MUNICIPAL SOLID WASTE PERMIT MAJOR AMENDMENT-3RD NOD RESPONSE

NAME OF PROJECT: Beck Landfill

MSW PERMIT APPLICATION NO.: 1848A

Major Amendment: July 2023

UTILITY TRENCH VENT DETAIL

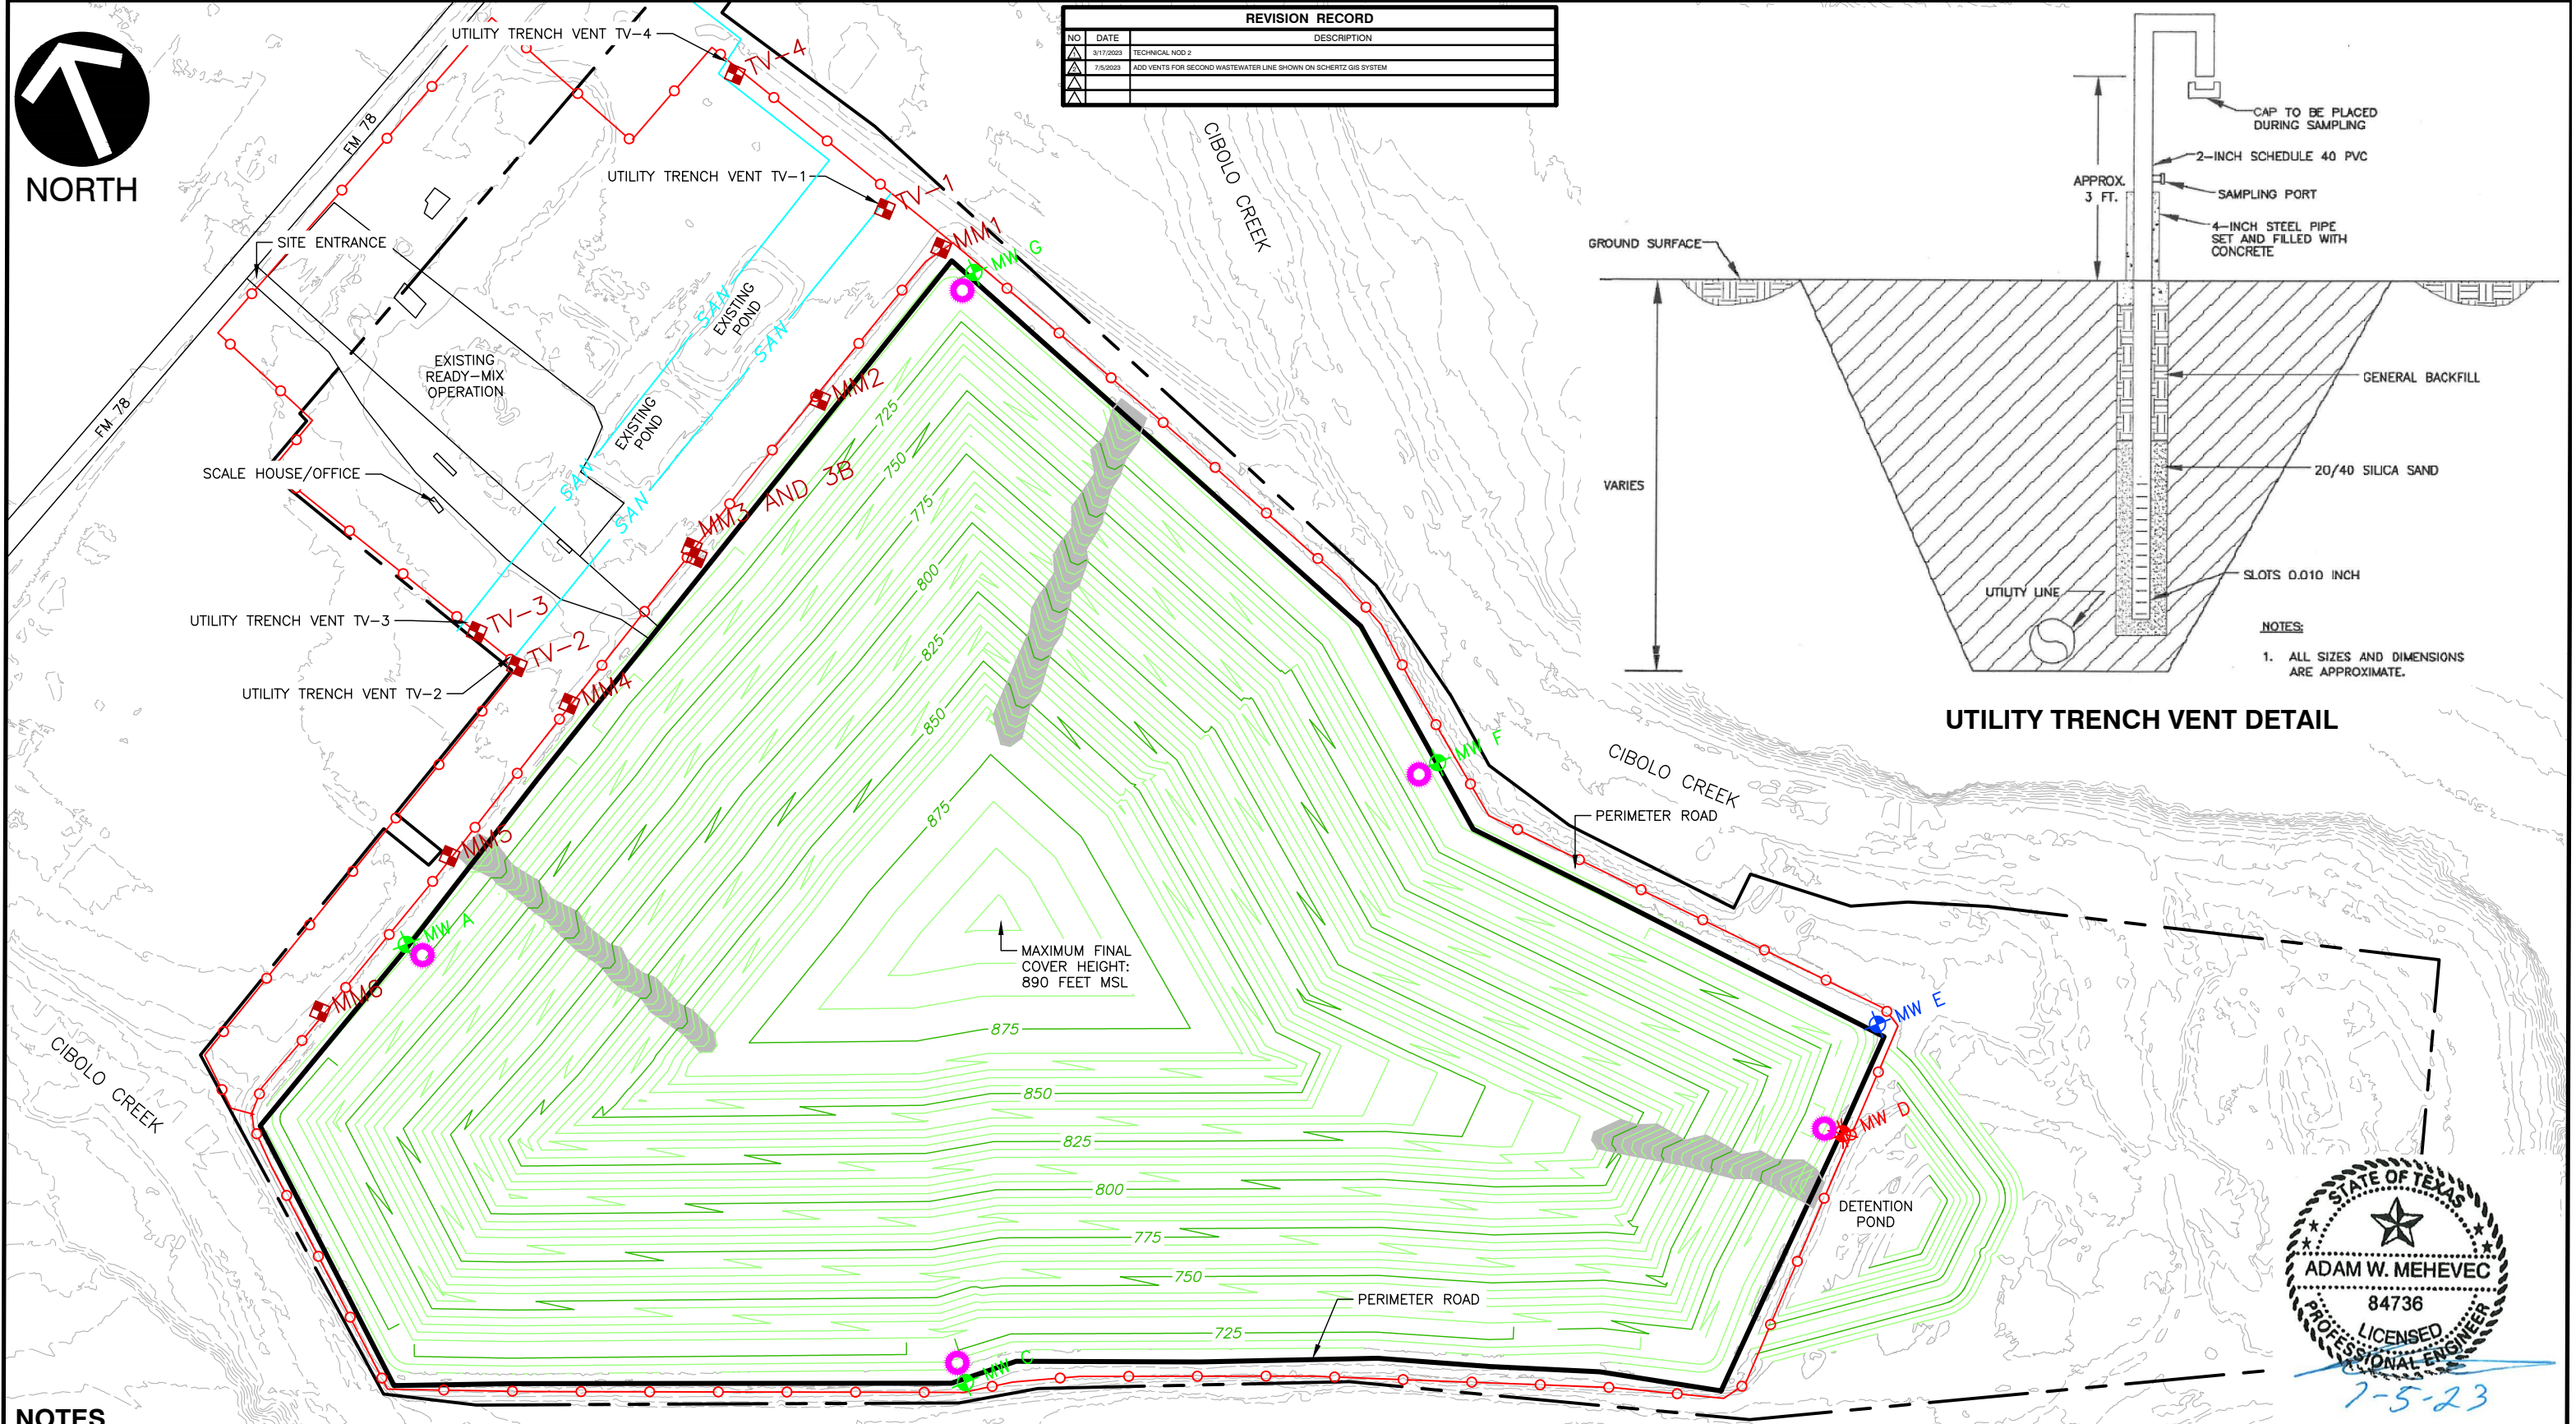
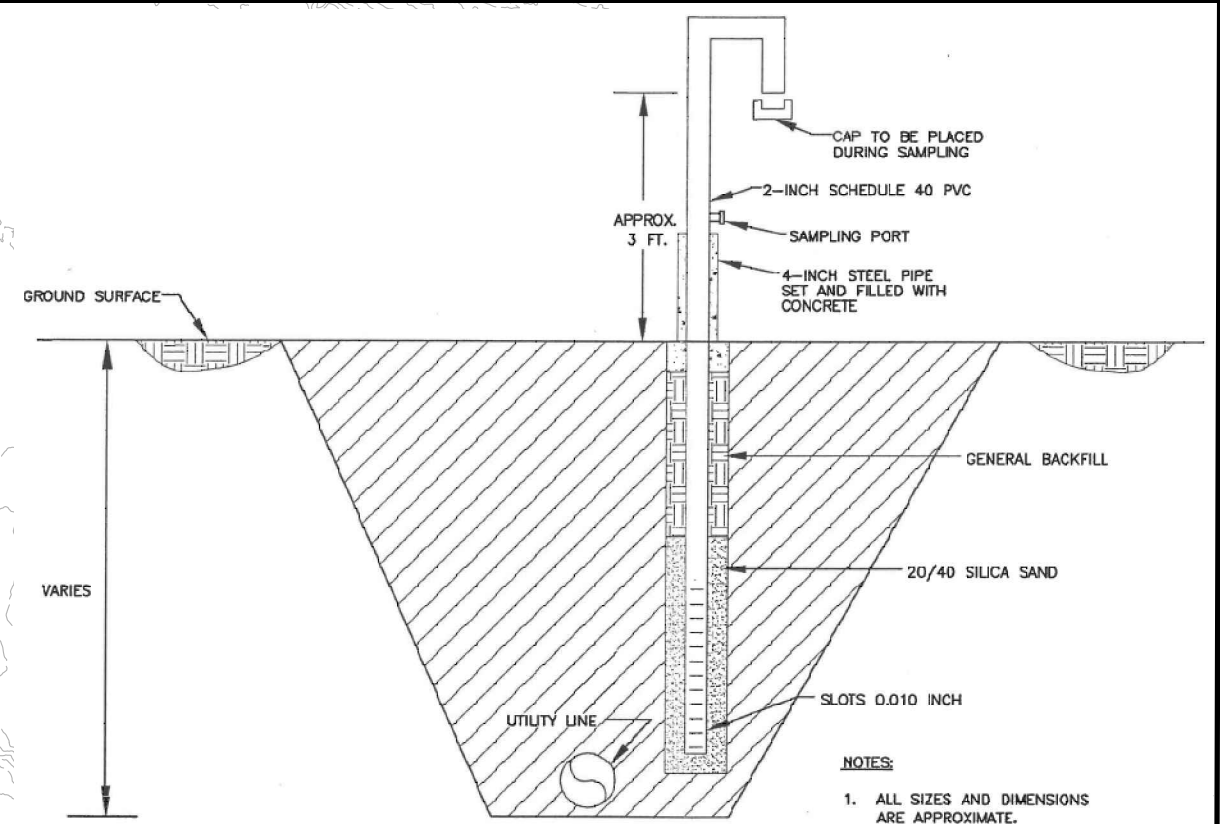
REVISION RECORD		
NO	DATE	DESCRIPTION
1	3/17/2023	TECHNICAL NOD 2
2	7/5/2023	ADD VENTS FOR SECOND WASTEWATER LINE SHOWN ON SCHERTZ GIS SYSTEM
